14th January 2025

Request to make a Minor Change Application for Approval COM/2019/82 | 18 Calli Avenue, Upper Coomera | Lot 142 on SP313554

Proposed Development Site Plan – Plantation Homes (3rd November 2024)

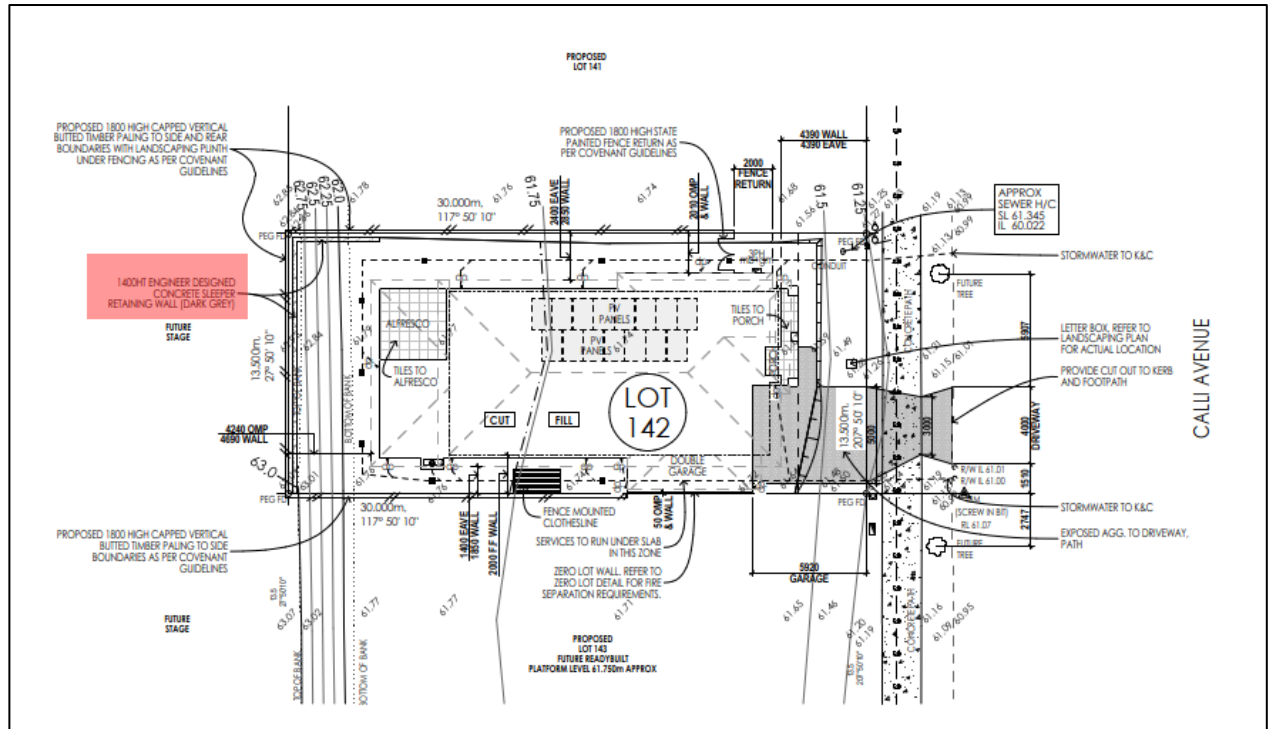
Further, as per the notes provided on the site plan above, retaining walls are proposed which have a height of 1400mm and are to be RPEQ Certified and constructed using concrete sleeps, dark grey in colour. These walls are not in accordance with the Retaining Wall Plan by Zone approved as part of COM/2019/82 and are the purpose of this application.

a. Retaining Walls on private land must be of concrete sleep construction and generally comply with the heights, locations and tiering extent included in the drawings listed below:

Drawing Title	Author	Date	Drawing No.	Version.
<i>Retaining Wall Heights</i>	<i>Zone</i>	<i>03.12.20</i>	<i>L19124 – A101 to A105; sheets 1-5</i>	<i>C</i>
<i>Lot 145 Proposed Site Plan with Retaining Walls</i>	<i>Plantation Homes</i>	<i>28.09.2024</i>	<i>9716-AHH</i>	<i>Revision 04</i>
<i>Lot 143 Proposed Site Plan with Retaining Walls</i>	<i>Plantation Homes</i>	<i>16.12.2024</i>	<i>9716-HAS</i>	<i>Revision 08</i>
Lot 142 Proposed Site Plan with Retaining Walls	Plantation Homes	03.11.2024	9716-WGO	Revision 10
